UNITED STATES PATENT AND TRADEMARK OFFICE

APPLICATION NO. FILING DATE FIRST NAMED INVENTOR ATTORNEY DOCKET NO. CONFIRMATION NO. SPEC-6150 6989 02/.12/2002 10/074,959 Avery J. Evans **EXAMINER** Allegiance Corporation RAMANA, ANURADHA Attn: Kim Diliberti 1430 Waukegan Road ART UNIT PAPER NUMBER McGaw Park, IL 60085-6787 3733 MAIL DATE DELIVERY MODE

(
		Application No.	Applicant(s)	
Office Action Summary		10/074,959	EVANS ET AL.	
		Examiner	Art Unit	
		Anu Ramana	3733	
The MAILING DATE of this communication appears on the cover sheet with the correspondence address Period for Reply				
A SHORTENED STATUTORY PERIOD FOR REPLY IS SET TO EXPIRE 3 MONTH(S) OR THIRTY (30) DAYS, WHICHEVER IS LONGER, FROM THE MAILING DATE OF THIS COMMUNICATION. - Extensions of time may be available under the provisions of 37 CFR 1.136(a). In no event, however, may a reply be timely filed after SIX (6) MONTHS from the mailing date of this communication. - If NO period for reply is specified above, the maximum statutory period will apply and will expire SIX (6) MONTHS from the mailing date of this communication. - Failure to reply within the set or extended period for reply will, by statute, cause the applic

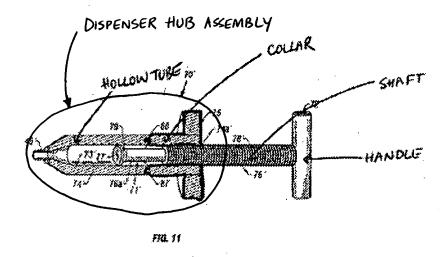
Preissman discloses a system for delivery of bone cement including: a plunger assembly with a shaft 76' having a threaded middle section and a handle 72 attached to a first end of the shaft; a dispenser hub assembly having a collar with an internally threaded portion and a handle 75; a hollow tube 74' removably engaged with the dispenser hub assembly; and a sealing element such as an O-ring 77' mounted on the shaft (Figs. 10-12C, 18, col. 11, lines 62-67, col. 12, col. 13, lines 1-13, col. 14, lines 11-67). Also see marked up Figure 11 on the following page.

Applicants' arguments regarding the rejections under 35 USC 102(b) based on Preissman are not persuasive. Claims 1, 29 and 30 recite "a dispenser hub assembly around said shaft, said dispenser hub assembly having a collar and a hand-grip attached to said collar." Preissman clearly shows a dispenser hub including a hollow tube, a collar and a hand grip attached to the collar. See marked up Figure 11 from Preissman in this office action.
